Status 2 - Disposition Needed **Trend** 01-Deviation From Doc/Proc
Department NCSX **Division** WBS 123
Source/Org FABRICATION, OPERATIONS & MAINTENANCE
Item Dwg/Part# SE121-008 R1 **Procurement #** _____ **Cost Center** _____
RAP# 3268 **Job Doc #** D-NCSX-FPA-001 **Vendor** _____
RAP Title Field Period Assembly Station One

VVSA-1 H/C Lines Dimensional Deviations – NCR #3910 – 4/16/07

Deviation #1 (Pictures 1 & 2) – 8” max spacing between tube runs.

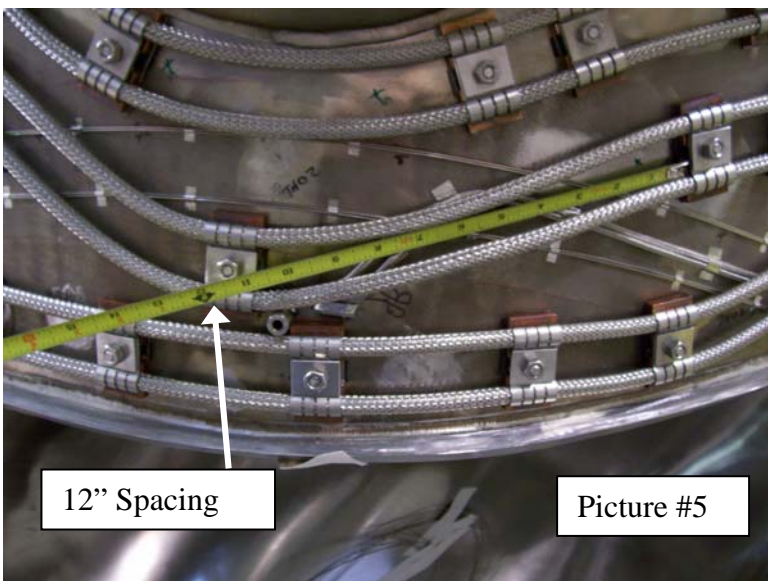
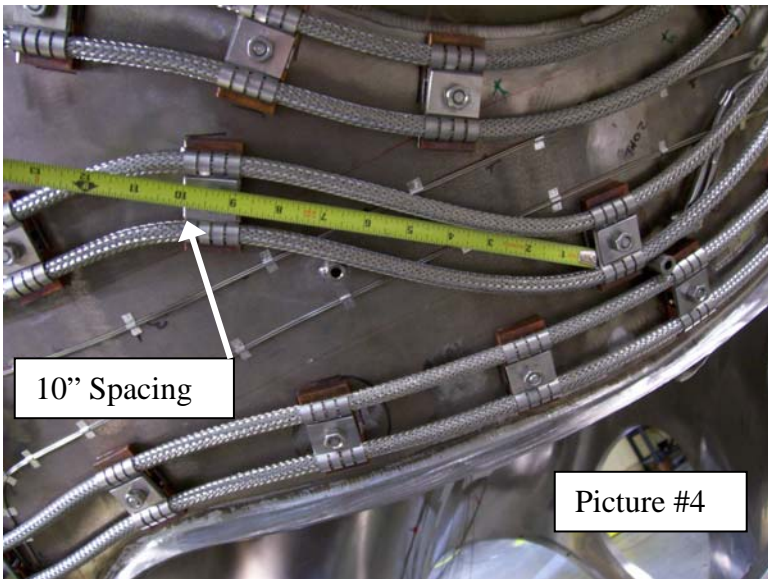
VVSA-1, On vacuum vessel sub-assembly #1 there are dimensional deviations with the placement of the heating and cooling lines, see below.
 Deviation #1 - Drawing SE121-008 R1 page 1 of 5 detail A states "Spacing between tubing runs to not exceed 8" max." See attached pictures 1 & 2.
 Deviation #2 - Procedure D-NCSX-FPA-001 R1 paragraph 6.7.1 calls for a 5" spacing between H/C stud locations with a tolerance of +/- 1" along the length of the hose. See attached pictures 3 thru 6.
 Deviation #3 - Procedure D-NCSX-FPA-001 R1 paragraph 6.7.2 states "Use heating cooling tube saddle foot print as a guide to maintain a minimum distance of 1/4 inch from the flux loops." See attached pictures 7 thru 10.
